**Pipeline and Hazardous
Materials Safety
Administration**

Reference No. 24-0064

This letter is in response to your June 26, 2024, email requesting clarification of the Hazardous Materials Regulations (HMR; 49 CFR Parts 171-180) applicable to the packaging requirements for lithium ion batteries. Specifically, you state that a customer is requesting your company manufacture a packaging for six lithium ion batteries consisting of a plastic pallet base, a plastic outer sleeve, and a plastic pallet lid banded together and holding two foam trays inside which contain the six individual batteries. You state that each battery weighs 56.7 kg and has a strong, aluminum outer casing. Lastly, in your email you provide drawings of the proposed configuration and a picture of a single lithium ion battery. You ask whether the foam trays “holding” the batteries need to meet the inner packaging requirements specified in § 173.185(b).

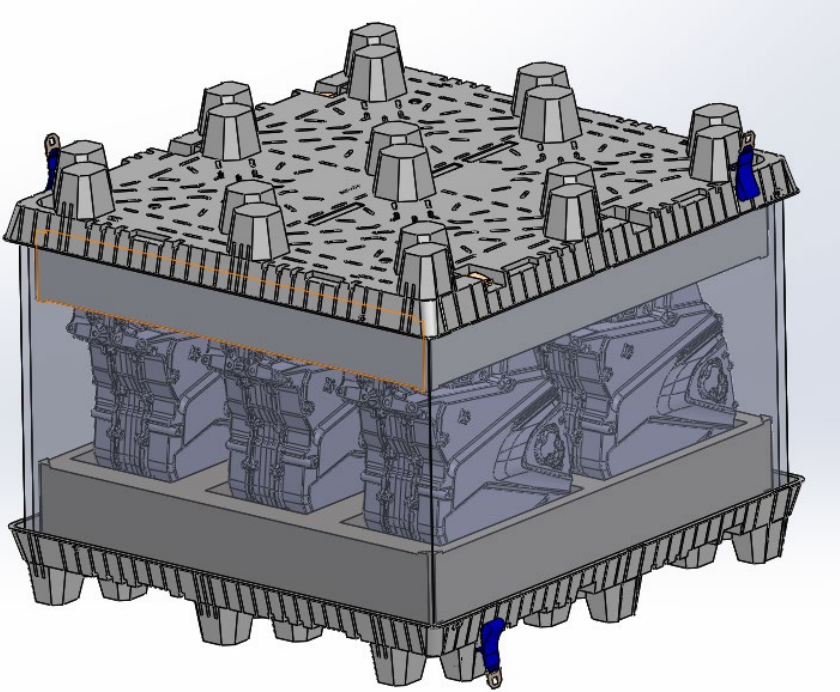
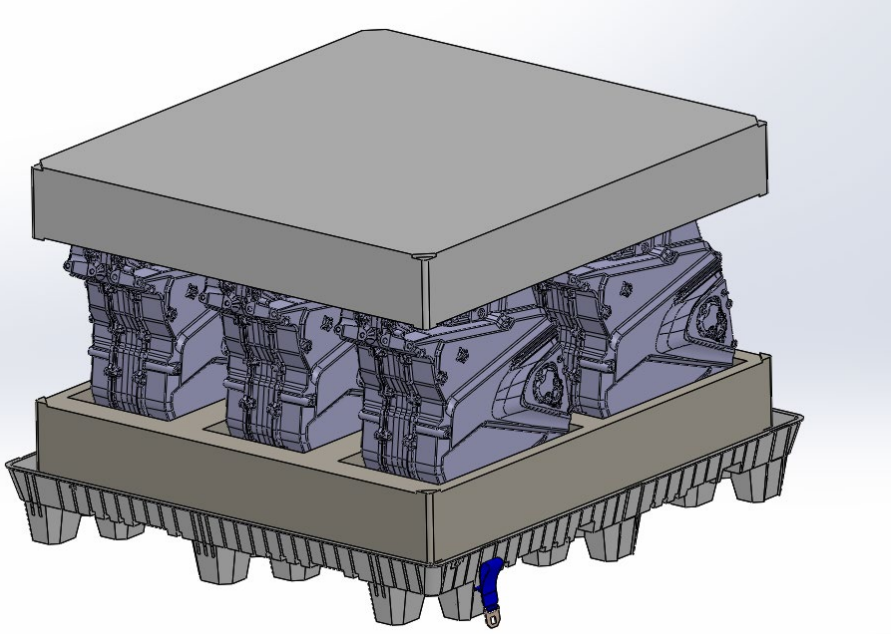
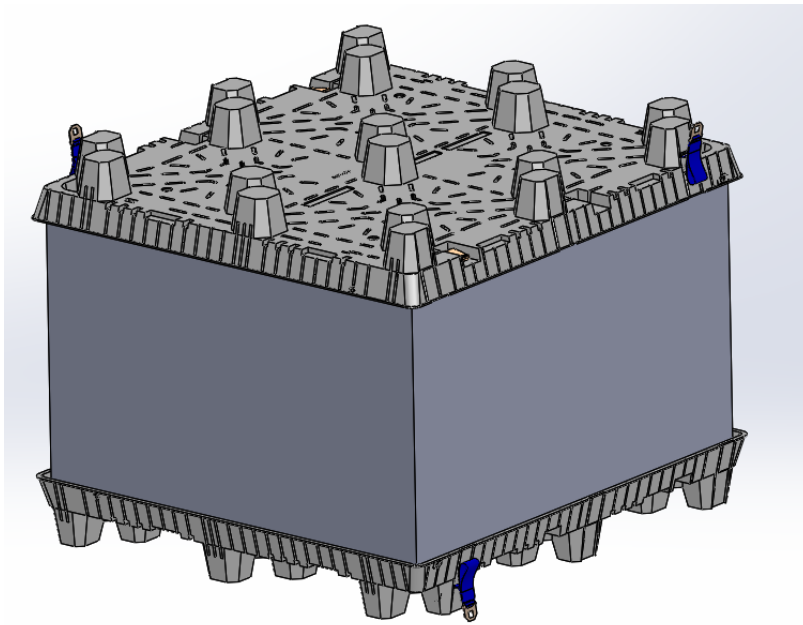
Here is our proposed packaging for 6 batteries. Plastic pallet base, plastic outer sleeve, and a plastic pallet as the lid banded together. The 2 foam trays on the inside hold the batteries and

keep them separated as a load unit. My question is around the 2 foam trays holding the batteries and the UN Inner Packaging requirement.

They still want our packaging to be UN tested and approved. So total loaded pack weight with batteries is 825 lbs so we are planning on doing the 5 side drop test for UN packaging approval. I know we have the Outer packaging requirement met with the pallet/sleeve/pallet lid, but my question is if the foam trays holding the 6 modules on the inside meet Inner packaging requirements or if that foam needs to completely enclose each battery and have the foam fill the inside of the packaging?

The answer is no. Section 173.185(b)(3)(i) requires lithium cells or batteries to be placed in non-metallic inner packagings that completely enclose the cells or batteries and separate the cells or batteries from contact with equipment, other devices, or electrically conductive materials (e.g., metal) in the packaging. The packaging configuration described in your letter would not meet this requirement because the inner packaging does not completely enclose the batteries. However, in accordance with § 173.185(b)(5), lithium cells or batteries that weigh 12 kg or more and have a strong, impact-resistant outer casing, may be packed on pallets or other handling devices instead of packages meeting the UN performance packaging requirements of § 173.185(b)(3)(ii) and (b)(3)(iii), including the inner packaging requirement of paragraph (b)(3)(i). Provided that the battery casing is strong and impact-resistant, the lithium ion batteries are secured to prevent inadvertent shifting, and the terminals do not support the weight of other superimposed elements, it is the opinion of this Office that the packing and handling arrangement you describe in your email is acceptable for highway transportation in accordance with § 173.185(b)(5).
